SUTHERLAND SHIRE COUNCIL ASSESSMENT REPORT

Panel Reference	PPSSSH-42
DA Number	DA20/0737
LGA	Sutherland Shire
Proposed Development	Construction of a new mixed use development consisting of 37 seniors living units and commercial tenancies
Street Address	1 Surf Road and 37 Gerrale Street, Cronulla
Applicant	Ashleigh Smith altered via formal request to Sage by Moran Pty Ltd on 08 March 2021.
Date of DA lodgement	15 September 2020
Number of Submissions	13
Recommendation	Refusal
Regional Development Criteria (Schedule 7 of the SEPP (State and Regional Development) 2011)	The application is referred to the SSPP as the development has a capital investment value of more than \$30 million and is nominated Schedule 7(2) of the State Environmental Planning Policy (State and Regional Development) 2011. The applicant's submission indicates that the proposed development has a value of \$30,747,851.00.
List of all relevant s4.15(1)(a) matters	<ul style="list-style-type: none"> • State Environmental Planning Policy (State and Regional Development) 2011. • State Environmental Planning Policy (Housing for Seniors or People With a Disability) 2004 (Seniors SEPP). • State Environmental Planning Policy

Figure 5. Section of Building (Source: Scott Carver, 2021)

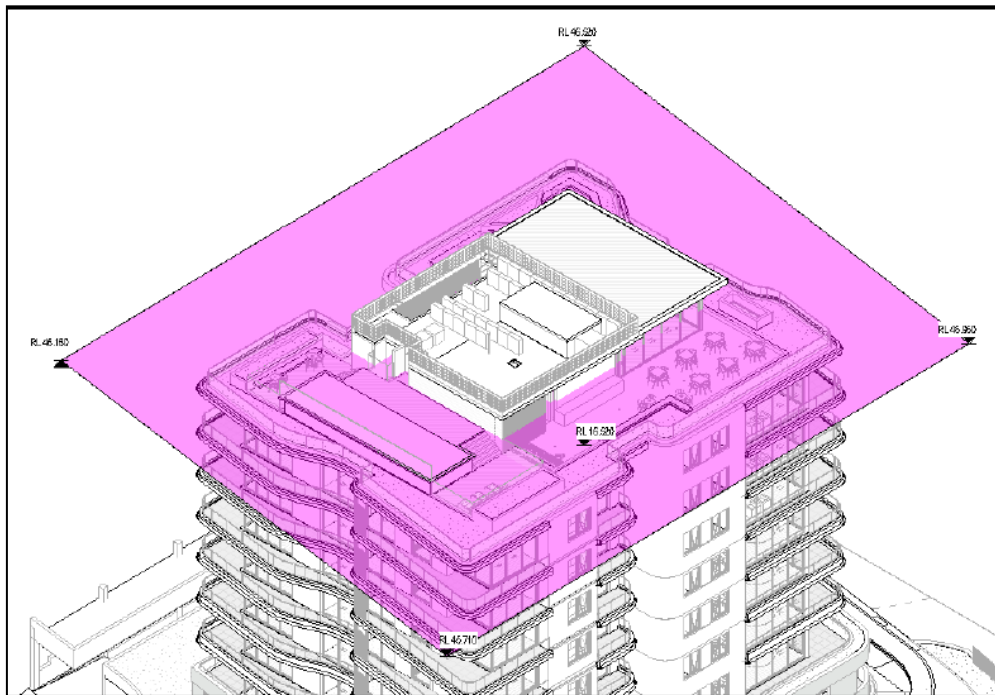
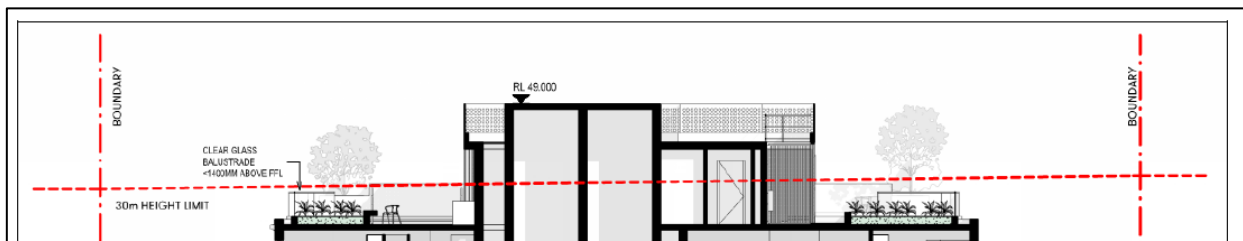
Clause 4.3 Height of Buildings of SSLEP 2015 stipulates a maximum height of 30m for this site. The proposed development fails to comply with the development standard for height, with a maximum height of 33m (10% variation) to the top lift overrun, roof top services and roof services screening.

The top half of the pavilion and pool fence also contravene the development standard with a maximum building height of 31.64m and 31.06m respectively. It is noted that all other roof top structures including balustrades, planter boxes and pool area (deck) comply with the maximum height limit. The diagram below shows the maximum height plane and the areas of the building which protrude through the height plane.

The applicant has been advised since the pre DA meeting that the building should be designed to comply with the building height development standard. The main issue with the height breach is the extent of the additional building mass above the height limit, being the entire building core, access and plant areas (footprint of approximately 150m²) plus the pavilion (approximately 106m²) and the pool fence. This is being driven by the applicant's desire to utilise a significant majority of the roof top area for communal facilities.

It is acknowledged that there may be justification for some roof top elements in this location where the breach may be subsumed by the form of the building and its surrounds. This could require a more compact approach to the layout. However, in this circumstance there is competition on the roof to accommodate a very large pavilion, vast areas of plant to a point where some elements are also required to be located higher than pavilion roof which itself breaches the height limit. Further to this, the roof top structures could be setback further from the edges of the building to be less visible from the street and adjoining buildings, including the glass balustrading and pool fence. The glass balustrades around the edge of the building are currently not a desirable architectural outcome as they fail to provide a solid band/visual terminus to the top of the building. Additionally, any screening required around rooftop plant areas should be a recessive feature rather than a 'stand out' feature and focal point.

Given the extent of the breach and the drivers being essentially an inwardly focused activity space for residents there is insufficient environmental planning grounds to support a variation to the height development standard in this regard. It cannot be seen as “a better outcome” for development in this particular circumstance.

ADG Separation and setback requirements

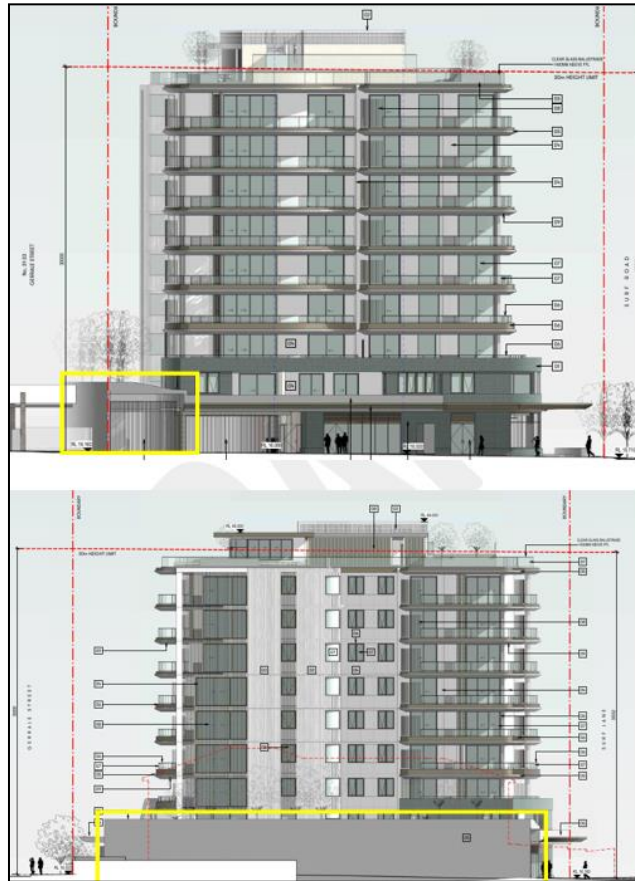
Section 2F of the ADG specifies minimum distances between buildings to guide an appropriate urban form and enhance the amenity of apartments and open space. The building does not comply with the prescribed separation distances from Levels 5 – 9 as the building is only setback 6m from the northern boundary, instead of the required 9m. The applicant claims that the reduced setbacks are a consequence of the need to accommodate for the reduced building footprint resulting from the dedication of the laneway / road widening required by the SSDCP 2015 (see section 10.12 below).

Notwithstanding the northern setback breach, the proposed built form is generally appropriate in its context, being located in the Cronulla Commercial Core and reflective of other similarly large buildings constructed or currently under construction in the immediate area.

Further to the setback encroachment detailed above, concern is raised about the visual prominence of the 5.5m high white blank wall that extends along most of the northern boundary. This will be visible from Surf Lane and Gerrale Street, albeit somewhat screened by the adjoining properties podium level and podium planting as shown in the photos below. The northern boundary wall is not an acceptable interface with the neighbouring property and fails to result in an adequate relationship with the established ground level context of the neighbouring development. Earlier versions of the architectural plans did not express a wall of the scale currently proposed.

9.8 View loss

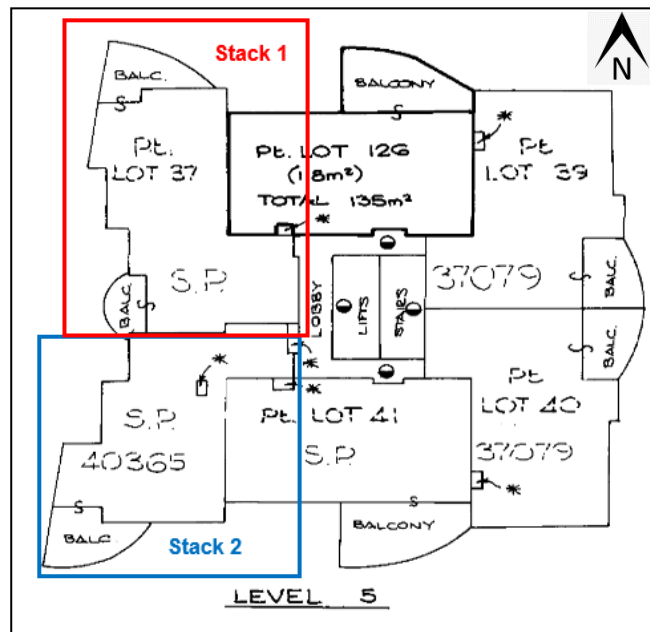
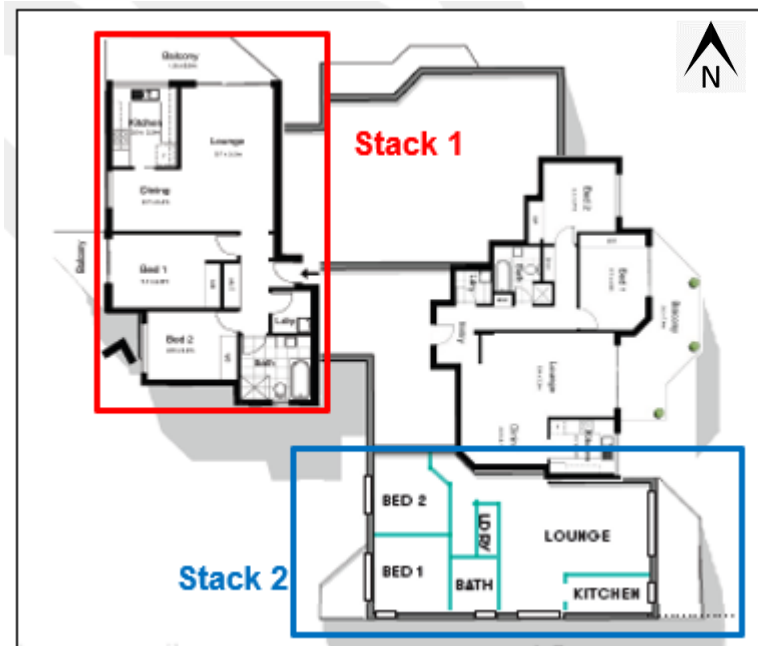
The affected views vary on vantage point (i.e. “stack” and elevation above ground). It is noted that the applicants ‘View Loss Analysis’ show that no views are currently obtained from residential levels 1 – 4. This appears to be correct given the existing built form on the subject site and beyond in the Cronulla Town Centre between the Cecil Apartments and Gunnamatta Bay.

The expectation to retain views across the subject site from The Cecil Apartments is unrealistic. The Cecil Apartments is situated approximately 300m from the foreshore of Gunnamatta Bay, setback behind multiple underutilised properties. Views currently obtained are over the top of under-utilised sites, which in the context of the town centre zoning and applicable planning controls, cannot feasibly be retained without significantly impacting on the development potential of these sites.

The proposal is non-compliant with the setback controls and maximum building height development standard. However, the Visual Impact Assessment contained within **Appendix “J”** shows that a compliant scheme does not result in the retention of the affected views. The retention of the existing views is not easily resolved and would reduce the development potential of the subject site and surrounding sites.

Considering the above, the view loss impact from the development is considered to be reasonable.
